# Access Compliance Report

## Public Rights-of-Way

### (Curb Ramps)

Intersection ID: 27563	Main Street: BALLANTYNE_FOREST_DR	Cross Street: LEDERER_AV	Location: NW
ADA ID: F0CAF090BD4E	Ramp Type: Perp	Initial Pass/Fail: Fail	Overall Compliance: No
Severity Score: 13.75			
Codes/Mitigation Info/Possible Solution		Field Measurements/Component Compliance

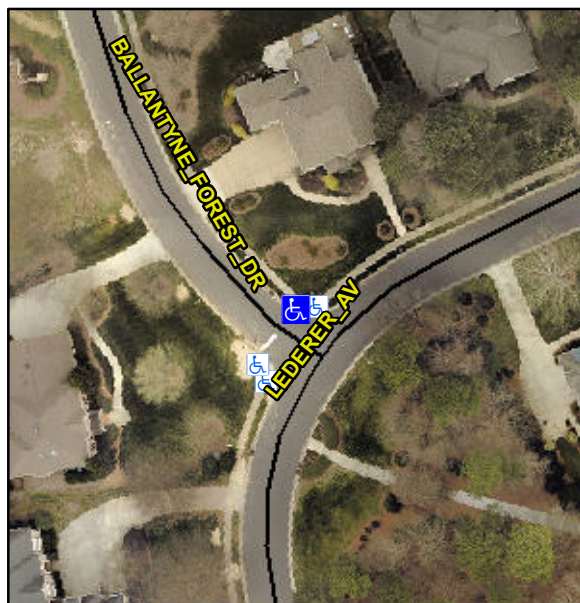
**Not Found, R304.2.2, R304.5.3**

Compliance	Description	Data	Compliance	Description	Data
N/A	Ramp Length (in)	34.0	No	Ramp Slope (%)	11.7
Yes	Ramp Width (in)	63.0	No	Ramp XSlope (%)	2.4
N/A	Flare Type LT	N/A	N/A	Flare Type RT	N/A
N/A	Flare Slope LT (%)	N/A	N/A	Flare Slope RT (%)	N/A
N/A	Flare Traversable LT?	N/A	N/A	Flare Traversable RT?	N/A
N/A	Landing Length (in)	N/A	N/A	DWS Provided?	N/A
N/A	Landing Width (in)	N/A	N/A	DWS Contrast?	N/A
N/A	Landing Slope (%)	N/A	N/A	DWS Length (in)	N/A
N/A	Landing X Slope (%)	N/A	N/A	DWS Full Width?	N/A
N/A	Landing Curb? (Y/N)	N/A	N/A	DWS Offset (in)	N/A
N/A	Shared Landing?	N/A			
N/A	Gutter Ponding?	N/A	N/A	Gutter Slope (%)	N/A
N/A	Gutter Lip Ht (in)	N/A	N/A	Gutter X Slope (%)	N/A
N/A	Painted X Walk1?	No	N/A	Painted X Walk2?	N/A
	X Walk 1 Direction	To SW		X Walk 2 Direction	N/A
N/A	X Walk 1 Width (in)	N/A	N/A	X Walk 2 Width (in)	N/A
	X Walk 1 Slope (%)	0.3		X Walk 2 Slope (%)	N/A
	X Walk 1 X Slope (%)	1.4		X Walk 2 X Slope (%)	N/A

**Remove & Replace Entire Ramp.**
